## STAFF RECOMMENDATION

312 South 11<sup>th</sup> Street

January 20, 2021

**Application:** New Construction—Addition; Setback Determination

Figures 2 & 3 show the right-side door and window configuration.

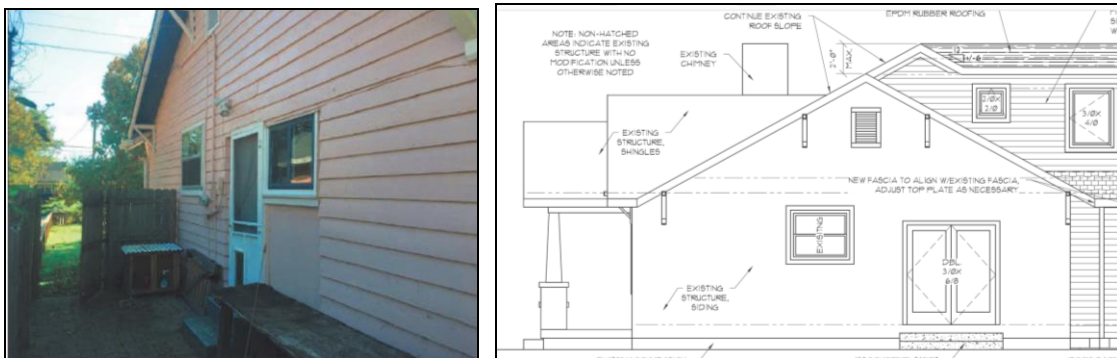
Partial Demolition. The applicant proposes to create a double door opening on the right side of the house, towards the rear, which is considered partial demolition (Figures 2 & 3). In most cases, staff finds that the creation of a double door opening on a side façade is not appropriate because that large of an opening was not seen historically on most side façades. Staff, however, finds the new opening to be appropriate in this instance because of the existing conditions on the house. The existing side façade has a door with a window directly next to it. The materials under this window have been replaced, and from the existing conditions, it appears that this used to be a door opening. For this reason and because the opening is in the back half of the side façade, staff finds creating a double door opening in this location to meet the design guidelines.

Staff finds that the proposed window and door opening alterations to be appropriate demolition and to meet Section III.B.1. of the design guidelines.

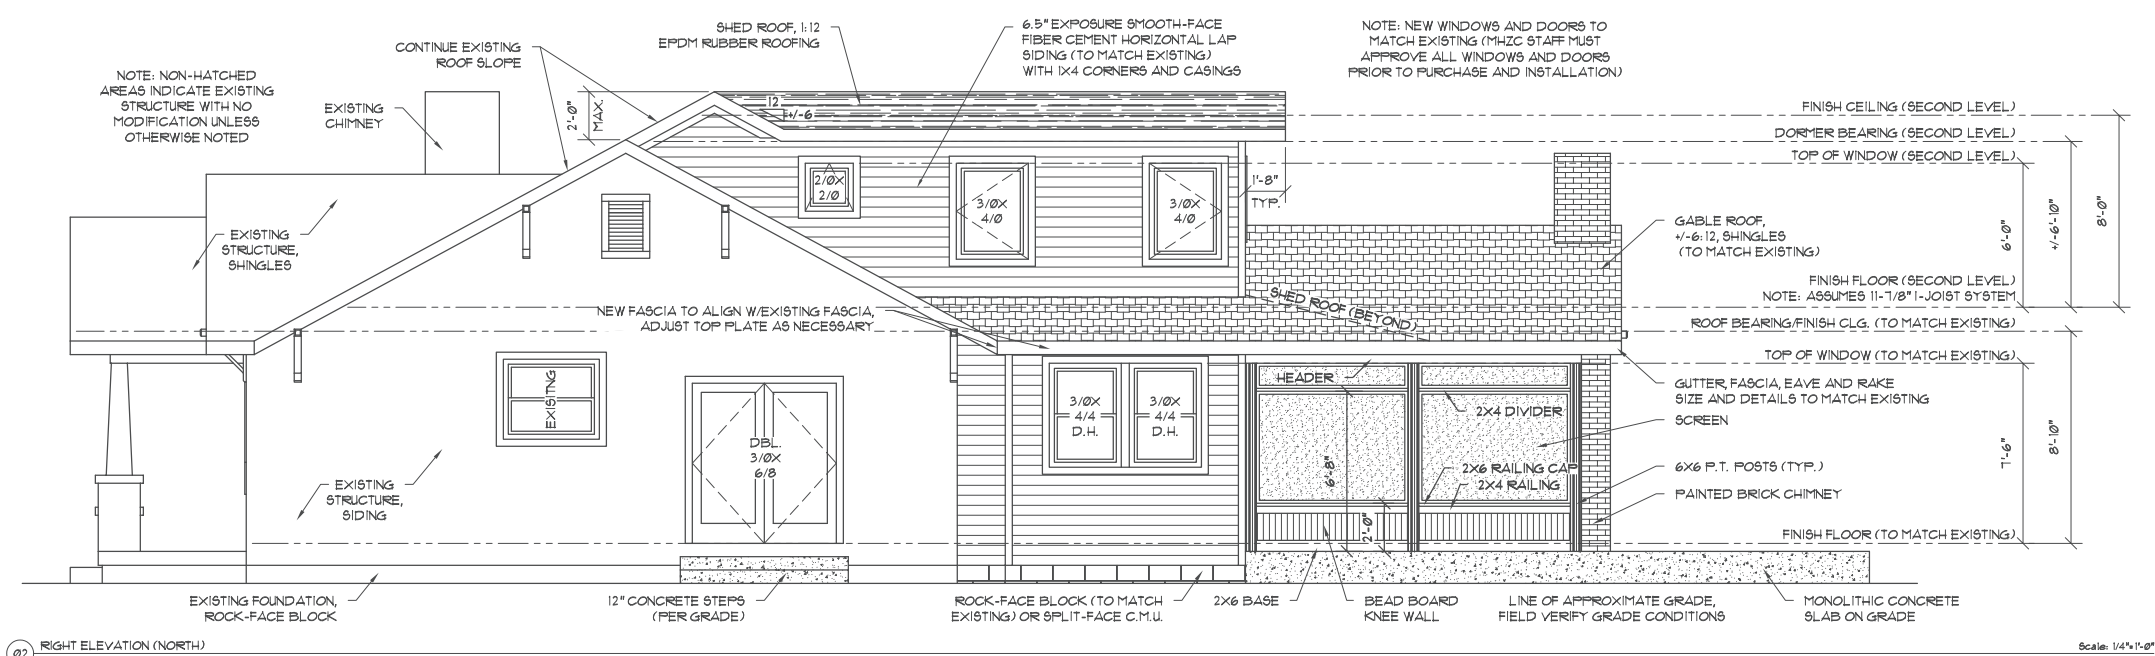
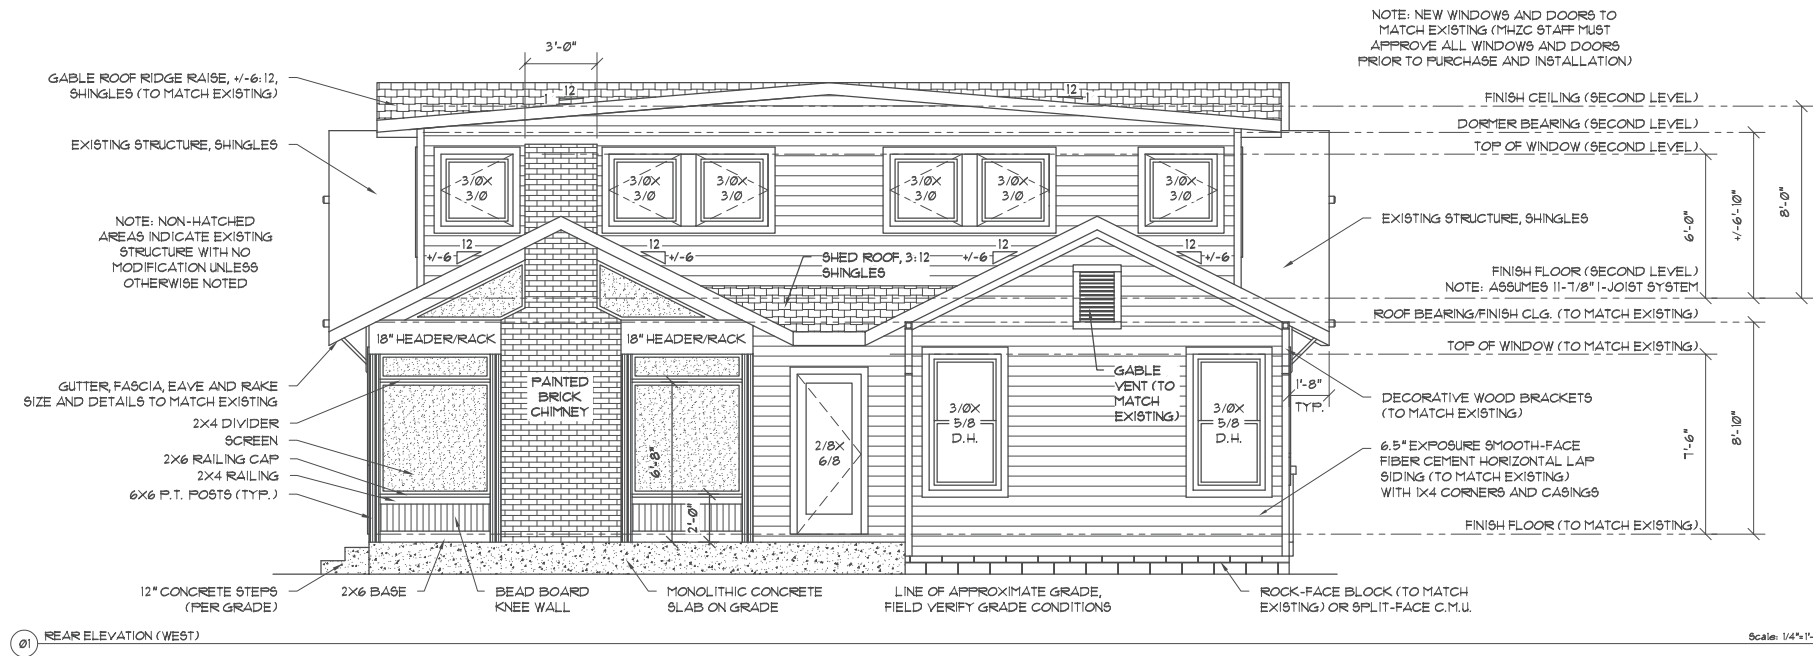
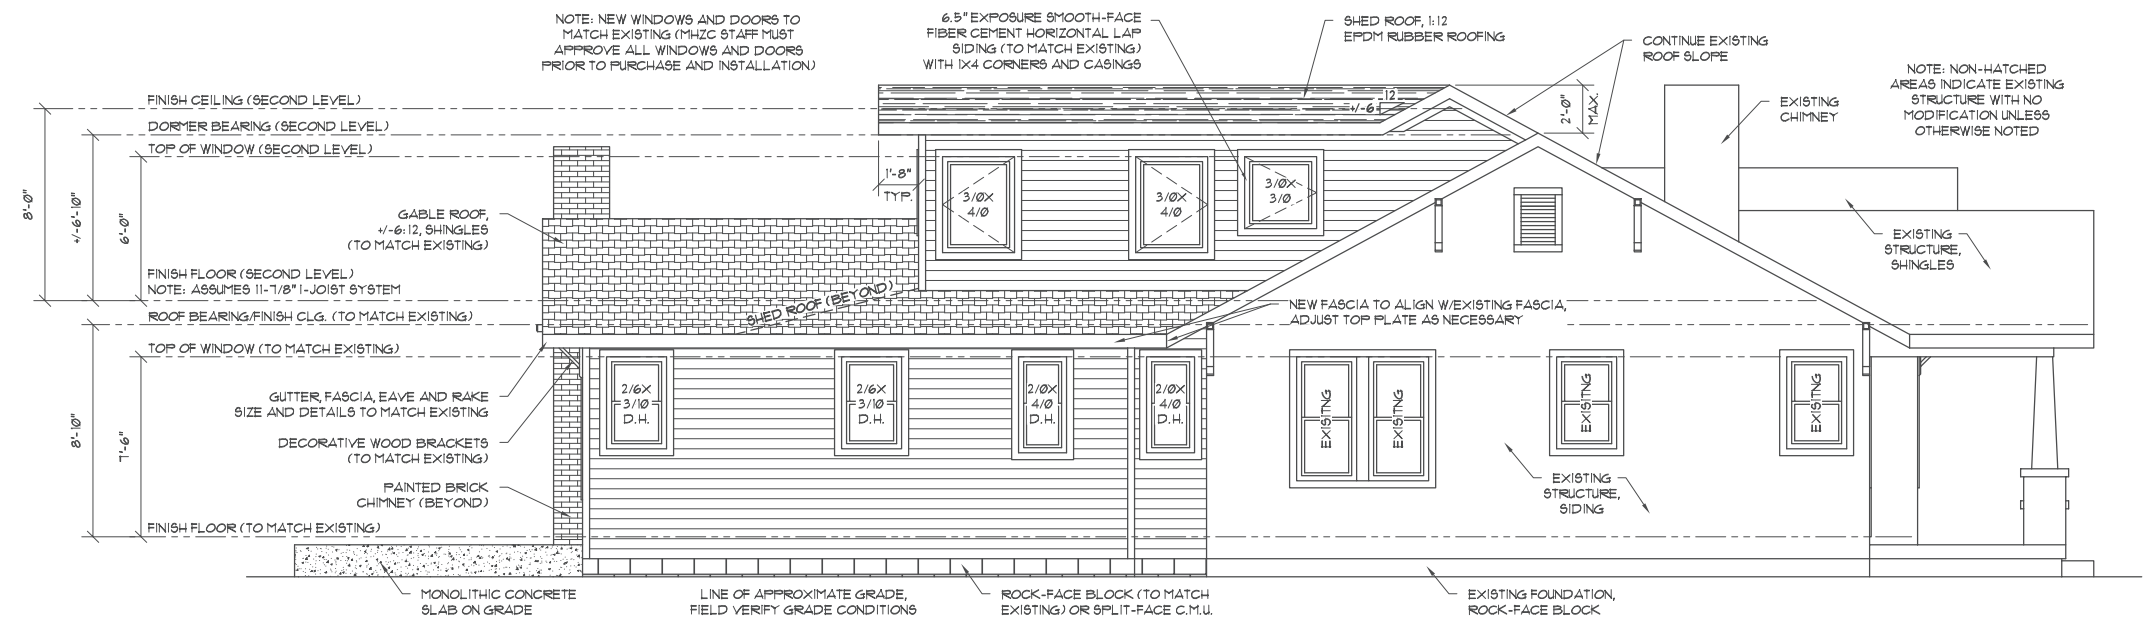
Height & Scale: The addition includes a two foot (2') ridge raise that is inset two feet (2') on both sides, per the design guidelines. On the ground floor, the addition insets one foot (1') for a depth of two feet (2') on the left side and three feet (3') on the right side, before stepping back out to line up with the side walls of the house. Staff finds this to meet the design guidelines. The second level of the addition is inset two feet (2') in its entirety. The addition will have a depth of twenty-six feet (26') and a footprint of approximately nine hundred and twenty-five square feet (925 sq. ft.), which is less than the house's historic footprint of approximately thirteen hundred square feet (1,300 sq. ft.) (Note, the project does not include removal of existing additions). Overall, the addition's height and scale is compatible with the historic house and the design guidelines.

Setback & Rhythm of Spacing: The addition meets the base zoning setbacks on the right side and on the rear, but not on the left side. On the right, the addition is nine feet (9') from the side property line. The addition is about one hundred feet (100') from the rear property line. On the left side, the addition is just two feet, six inches (2'6") from the property line, which does not meet the base zoning setback of five feet (5'). Staff finds the setback of two feet, six inches (2'6") to meet the design guidelines because the existing house is also two feet, six inches (2'6") from the side property line and the

Roof form: The addition includes a ridge raise that is inset two feet (2') on both sides and extends up two vertical feet (2'), per the design guidelines. The ground level's roof are 6/12 gables connected with a low shed. The dormers at the second level are low-sloped shed dormers. Staff finds that the addition's roof forms are compatible with the historic house's roof and meets Sections II.B.5. and II.B.10. of the design guidelines.

Proportion and Rhythm of Openings: The change to the window and door openings on the historic house are discussed under “Partial Demolition.” The windows on the proposed addition are all generally twice as tall as they are wide, thereby meeting the historic proportions of openings. There are no large expanses of wall space without a window or door opening. Staff finds the project’s proportion and rhythm of openings to meet Section II.B.7.

**Recommendation:** With the condition that staff approve all masonry samples, windows and doors, the roof shingle color, and the location of the HVAC and utilities, staff finds that the proposed addition meets Sections II.B. and III. B of the design guidelines for the Lockeland Springs-East End Neighborhood Conservation Zoning Overlay.
